MONTGOMERY COUNTY HISTORIC PRESERVATION COMMISSION
STAFF REPORT

Address:	22200 Clarksburg Road, Boyds	Meeting Date:	1/24/2024
Resource:	Master Plan Site Number 13/25 <i>Cephas Summers House</i>	Report Date:	1/17/2024
Applicants:	Pulte Homes	Public Notice:	1/10/24
Review:	HAWP	Tax Credit:	Partial
Permit No.:	956436 REVISION	Staff:	Chris Berger
Proposal:	Various retroactive and proposed revisions to house and outbuilding

STAFF RECOMMENDATION:

Figure 2. The cropped Resite and Lot Grading Plan included as part of this submission. The area between the front porch and property line along Clarksburg Road will be regraded and walkway will be added.

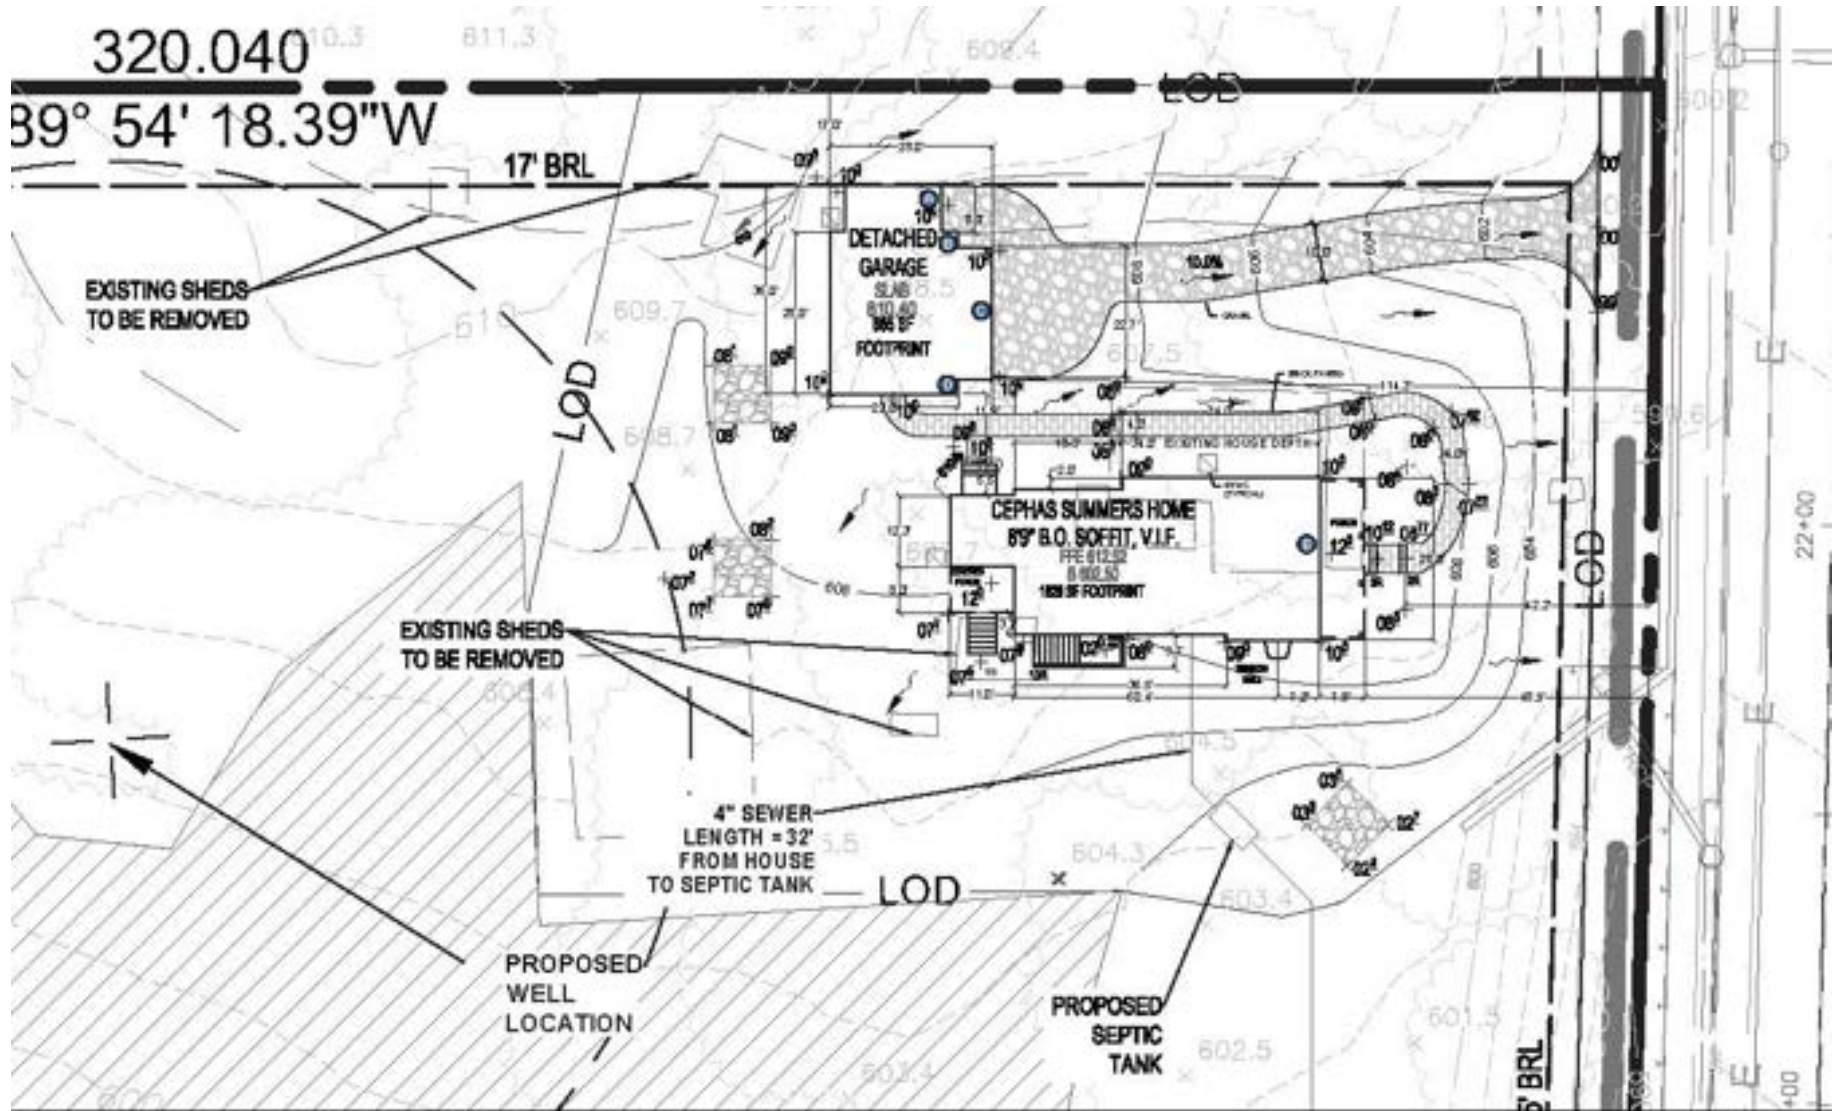
Staff believes the most noteworthy change is the proposal to regrade the property proximate to the front porch so it better matches the property's traditional grading. The front porch floor currently is elevated as much as 4' from grade, and the restoration of the grading will result in a drop of less than 30 inches from

- Proposal to grade the yard and add a 4’ wide brick walkway from the garage to the front door. According to the applicants, the work will not require a retaining wall.

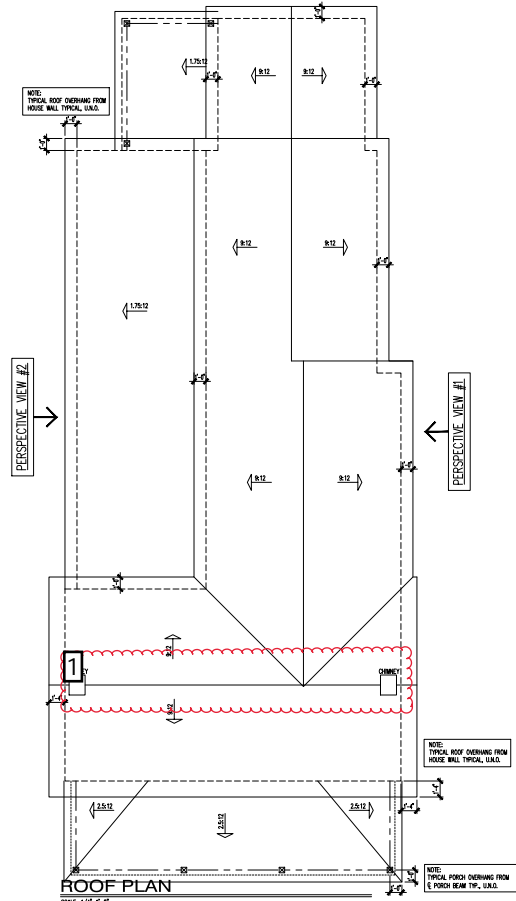
As part of the revised HAWP, the applicant will submit documentation (drawing/photographs) for the relocation of the rebuilt chimneys. Please include the distance from the rake/edge of the roof to the chimney. Include a written narrative that outlines the structural reasons for their current position.

As part of the revised HAWP, the applicant will submit documentation (drawing/photographs) for the relocation of the rebuilt chimneys. Please include the distance from the rake/edge of the roof to the chimney. Include a written narrative that outlines the structural reasons for their current position.

As part of the revised HAWP, the applicant will submit revised specifications and photographs that show the 1 3/4" muntin width of the installed window.

The applicant will remove the installed TREX and install wood, tongue-and-groove, porch flooring. The floor should run perpendicular to the house.

1. Refer to the photographs below detailing the location for the rebuilt chimneys. They are located 12" from the edge of the roof. In order to provide structural support for the chimneys, steel angles lintels were required. These loads associated were transferred down to the roof girder trusses below.

1. Chimney's – addressed above.
2. Photos below detail the 1 ¾" muntin width of the installed window. Refer to Exhibit 2 for updated window specifications.

3. The trex decking flooring will be removed. It will be replaced with 1"x 4" tongue and groove wood. The floor will run pedicular to the house as detailed on the revised drawings. Refer to Exhibit 2 for specifications.

PROPOSED RIGHT SIDE ELEVATION
SCALE 1/4" = 1'-0"

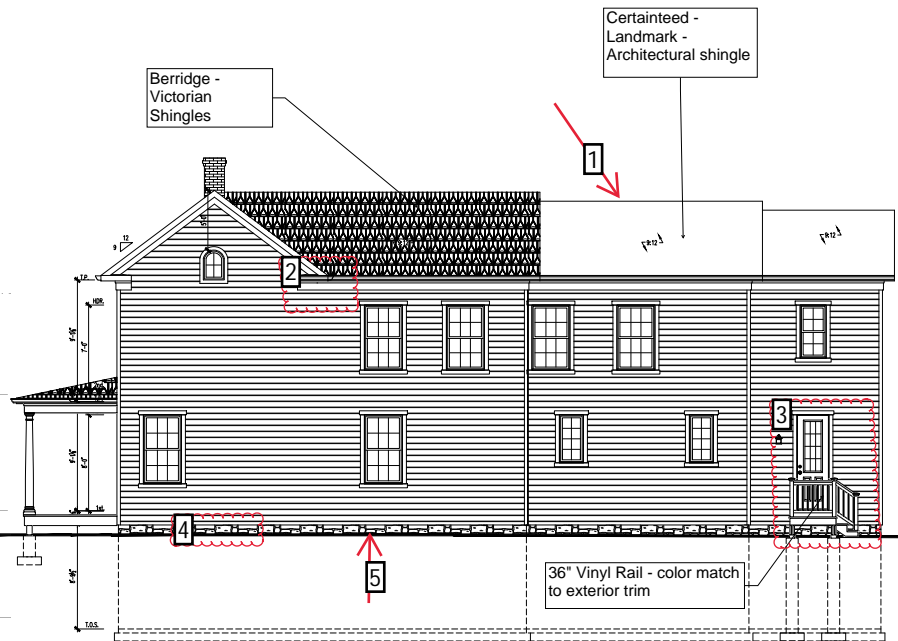
As part of the revised HAWP, include locations and specifications for all lighting.

As part of the revised HAWP, include the specifications and locations of all gutters, downspouts, vents, etc.

As part of the revised HAWP, submit the specifications and dimensions of any HVAC equipment.

PROPOSED REAR ELEVATION
SCALE: 1/8" = 1'-0"

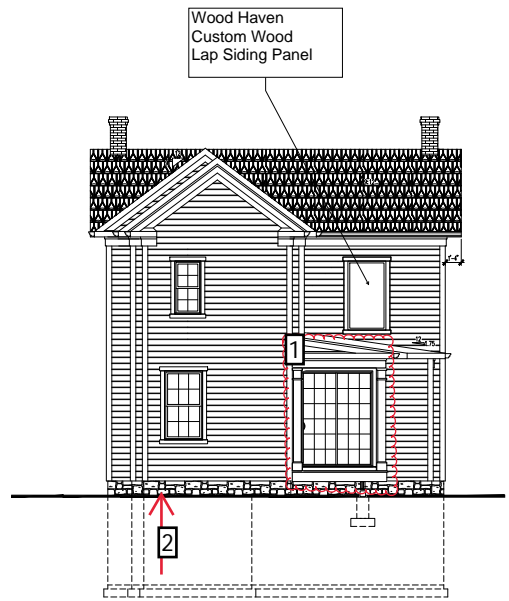
As part of the revised HAWP, include the specifications and locations and specifications for all lighting.

As part of the revised HAWP, include the specifications and locations of all gutters, downspouts, vents, etc.

As part of the revised HAWP, submit the specifications and dimensions of any HVAC equipment.
